Public Comment on Planning Board Site Plan Review Item “D” 94 Langdon Street/98 Cornwall Street

From: David Rheume, P. E.

To: Planning Board Chair Rick Chellman and Planning Board Members

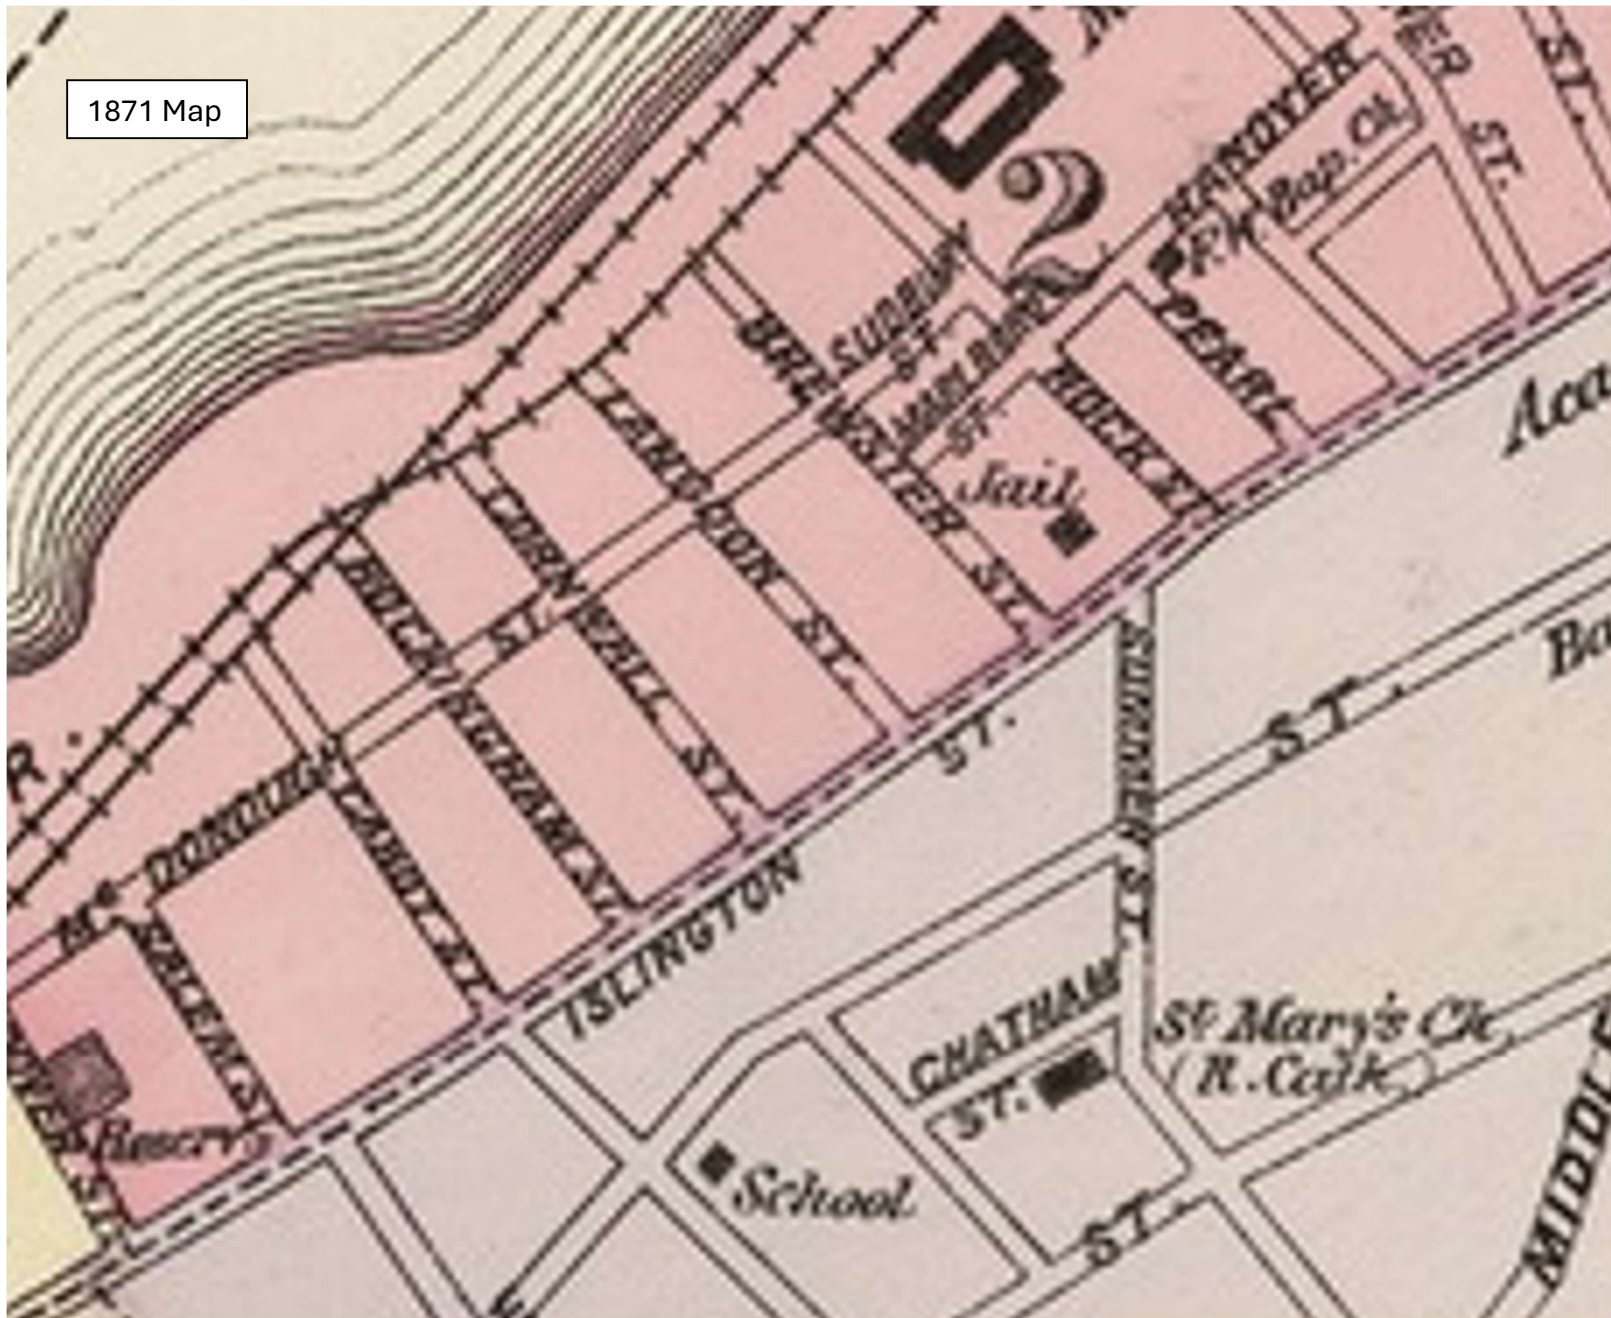
An excerpt from the developer’s application to Planning Board is shown on page 4. It depicts the planned layout for the three single-family dwelling units, as well as the proposed common driveway that exits onto Langdon Street. It also illustrates that proposed Dwelling Unit 1 is oriented at a right angle to Langdon Street. The common driveway near Dwelling Unit 2 and Dwelling Unit 3 features a curve and vehicle turnout that almost connect to Cornwall Street.

The apparent vehicle turnaround shown on the applicant’s site plan could be reconfigured to be an ingress from Cornwall Street along the 48 feet of frontage that Lot 139-1 has along the east side of the street. This would leave room at the end of Cornwall Street for snow accumulation due to street plowing in the winter.

Elimination of the common driveway leading to Langdon Street could allow for a home to be positioned parallel to the street with a driveway having two parking locations in front of a two-car garage, mirroring the current configuration of the homes at 81, 82, 91 and 101 Langdon Street. It should still be possible to include a walking path from Dwelling Unit 2 and Dwelling Unit 3 across Condominium-owned land adjacent to Dwelling Unit 1 to allow pedestrian access for those two units to Langdon Street, facilitating easy walking access to Rock Street Park.
